Brookwood Medical

Design Review

101 Brookwood and 884 & 1000 2nd Street

September 1, 2022

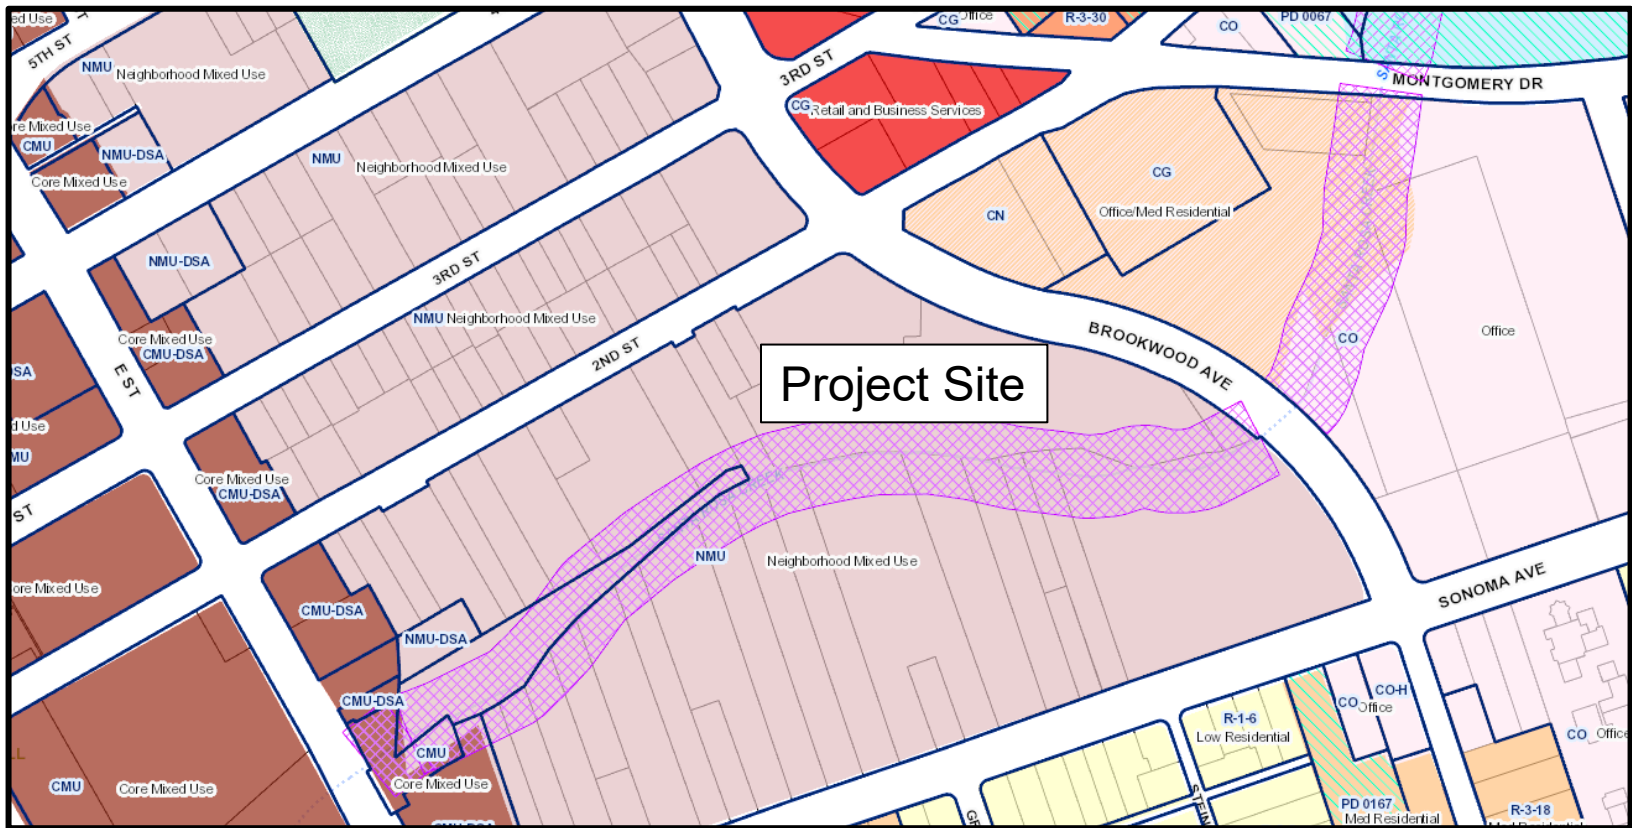
Suggestions

- Spruce up the front corner
- Not in favor of garage location
- Consider increasing the size
- Add access points on street-facing elevations

Compliments

- Mosaic pattern of windows
- Perforations in the garage structure
- Landscaping & creek path
